**Re: Revised Site Plan for 51 & 57 Tannery Street & 208 Emby Drive, City of Mississauga,
Mississauga File: OZ/OPA 18 012**

The purpose of this reliance letter is to provide confirmation that the findings, recommendations, and conclusions outlined in our previously submitted studies remain applicable to the proposed Site Plan.

SITE PLAN
TANNERY TOWNHOMES - 147 UNITS

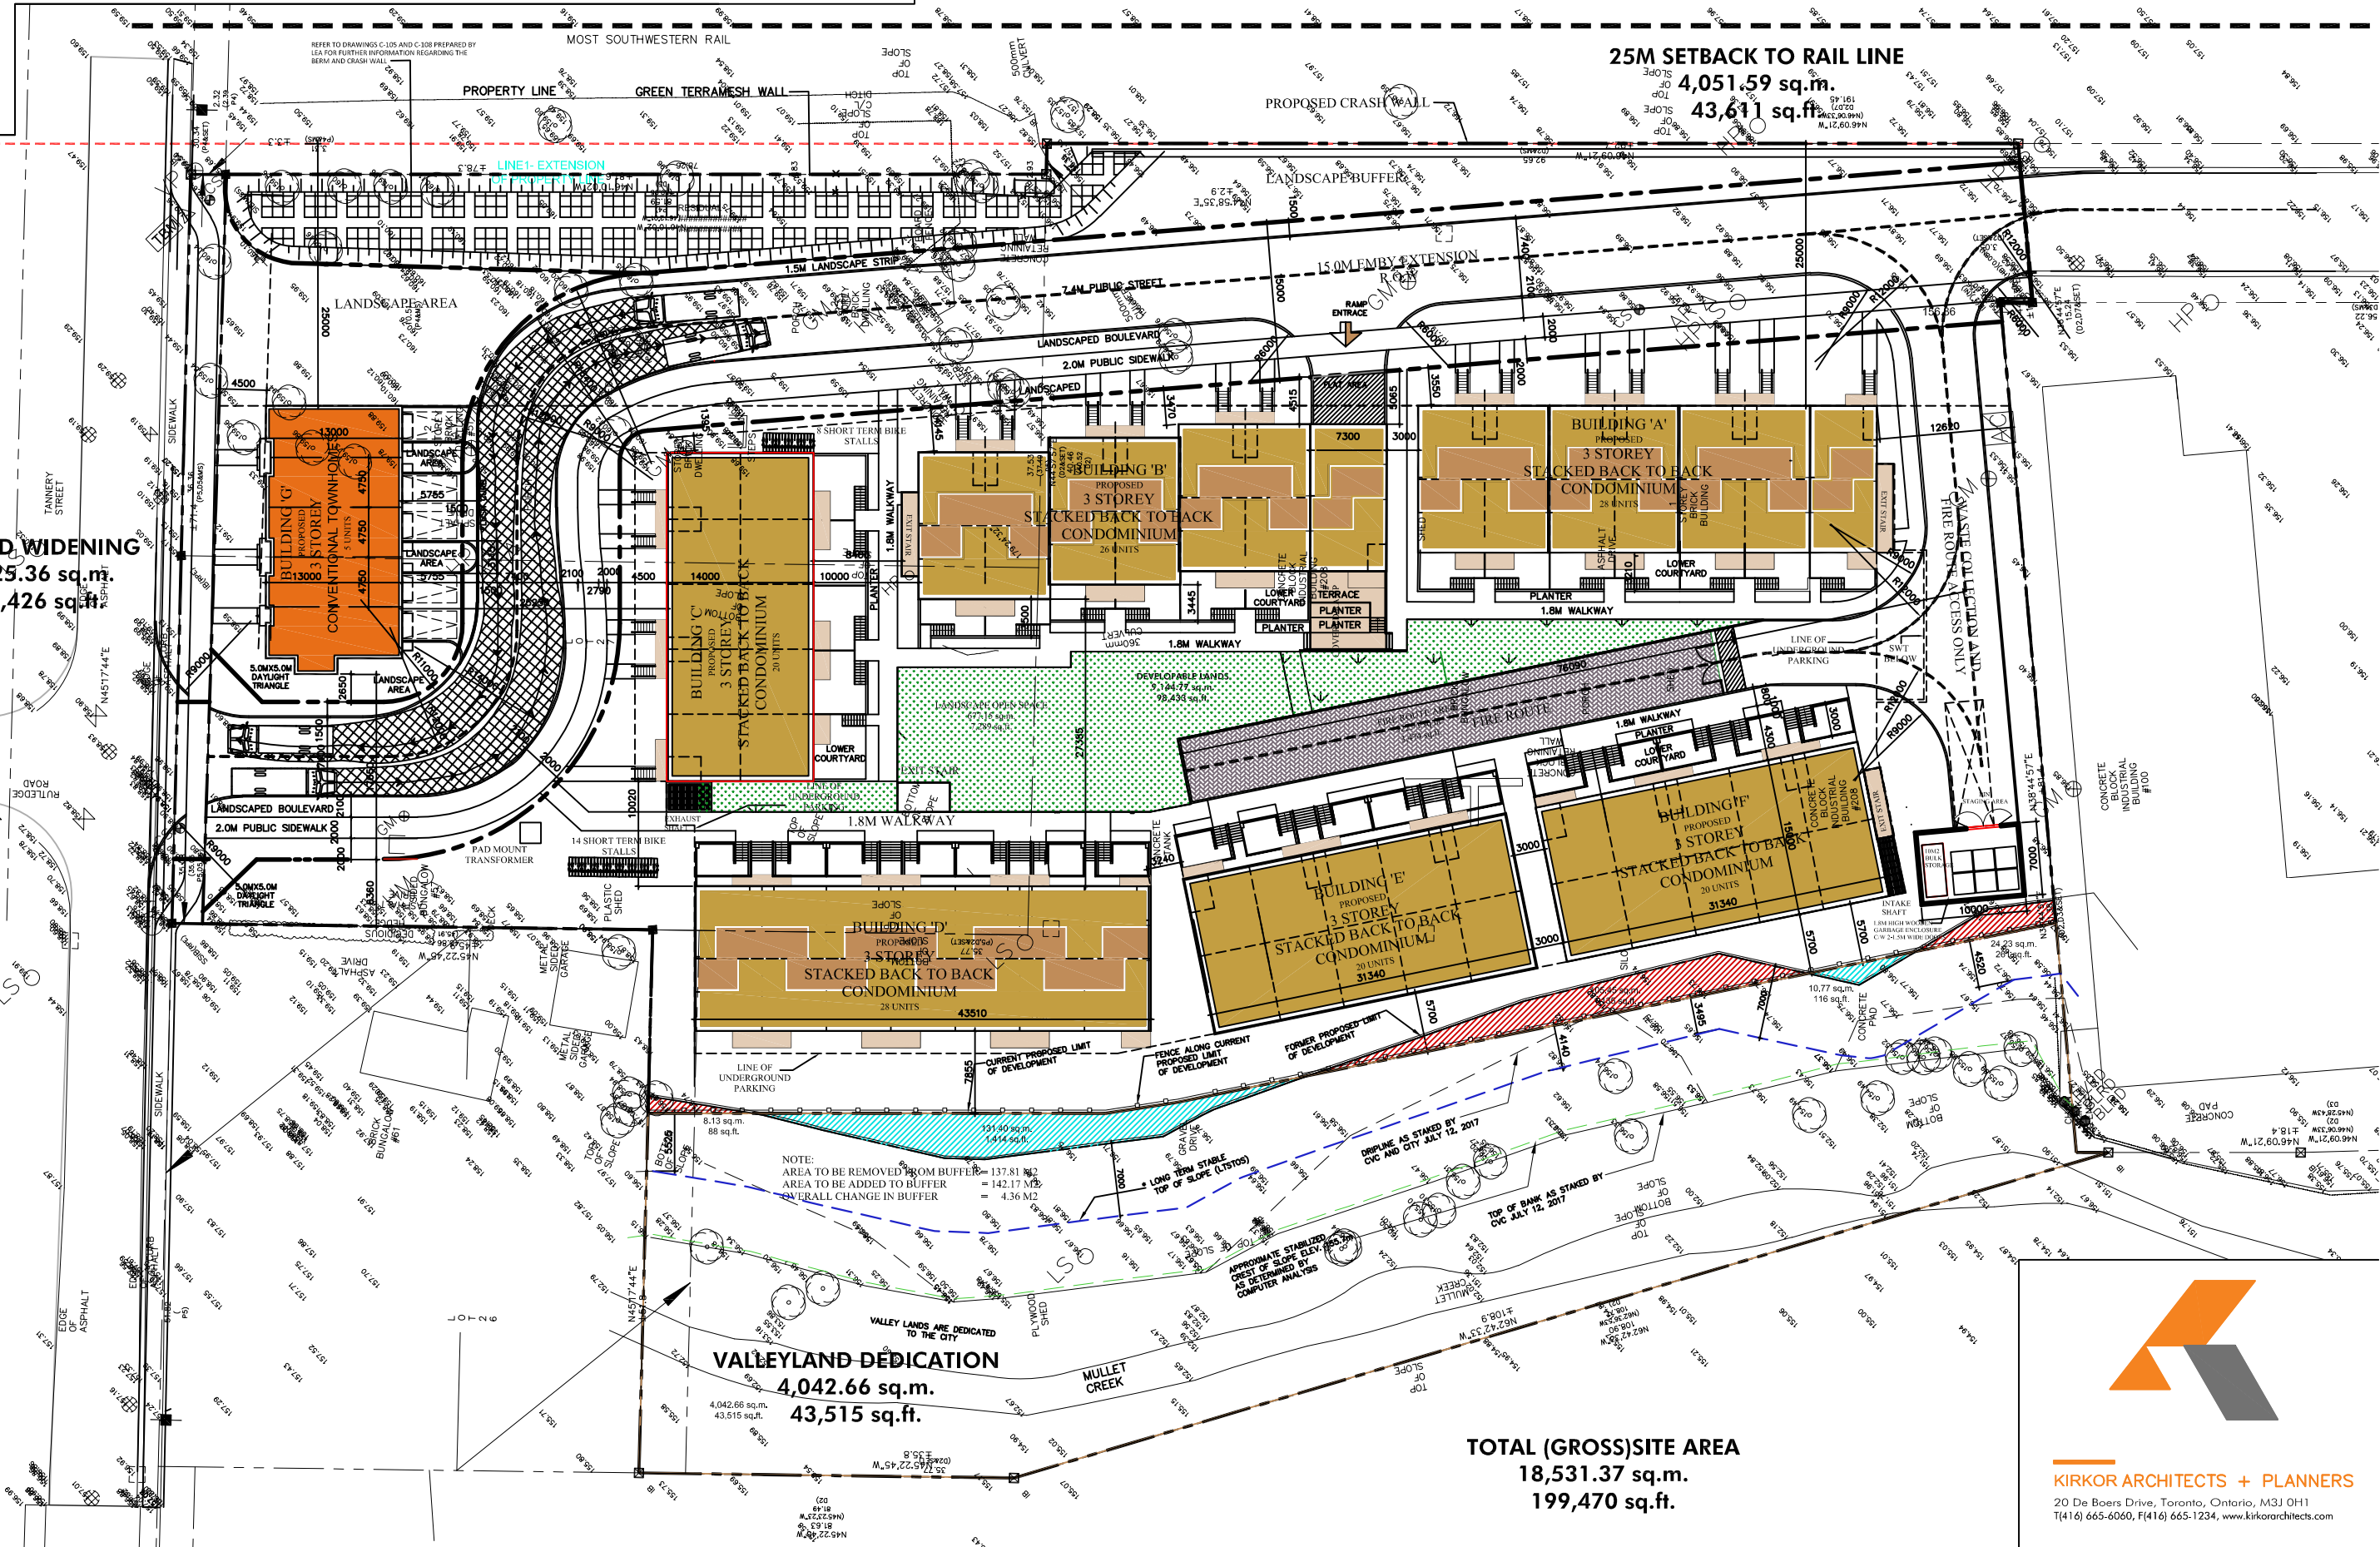
As was noted above, the only change to proposed Site Plan has been a modification of the development limit. The previous development limits were established by applying a uniform 7.0 m setback to the Long-Term Stable Top of Slope (LTSS) determined by Patriot Engineering (2019). This irregular line intruded into the central portion of the site and fell away to the north, thereby constraining setbacks to the rears of Buildings E & F. To smoothen or regularize the development limit, the Site Plan has been adjusted to reduce the setback adjacent to Buildings E and F and increase it adjacent to Building D. These modifications result in a LTSS setback that exceeds 10 m for approximately half of the setback

with the remainder ranging in width from 3.5 m to <10 m. The net change to the overall setback area is +4.36 m². These changes, including dimensions and area calculations, are highlighted on the attached Site Plan.

**TREE INVENTORY
AND
PRESERVATION PLAN**

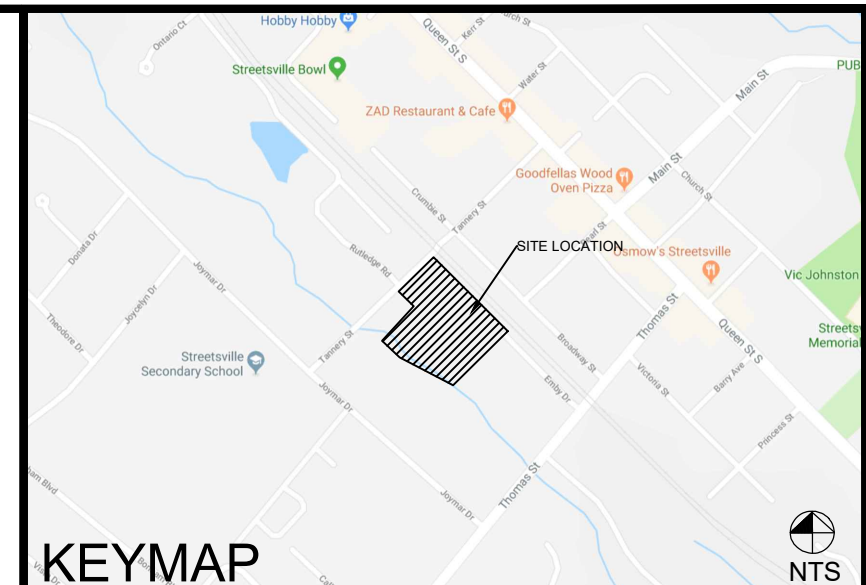
The revised Site Plan has the potential to affect one additional tree at the western corner behind Building D. Tree 470 is a small multi-trunked hawthorn in fair condition. Under the previous Site Plan, this tree was located on the limit of development line but was retainable due to the requirement to match grading

at the development limits. Under the proposed Site Plan, the limit of development has been extended approximately 1.5 m further southwest and the tree will now likely be in conflict with grading. The loss of this additional tree will not have a significant affect on overall tree canopy and diversity, as there will be substantial tree replacement provided through the Valleyland Restoration and Enhancement Plan that will be prepared as a conditions of Site Plan approval. The Tree Inventory and Preservation Plan has been updated and is attached to this letter as **Attachment B**.
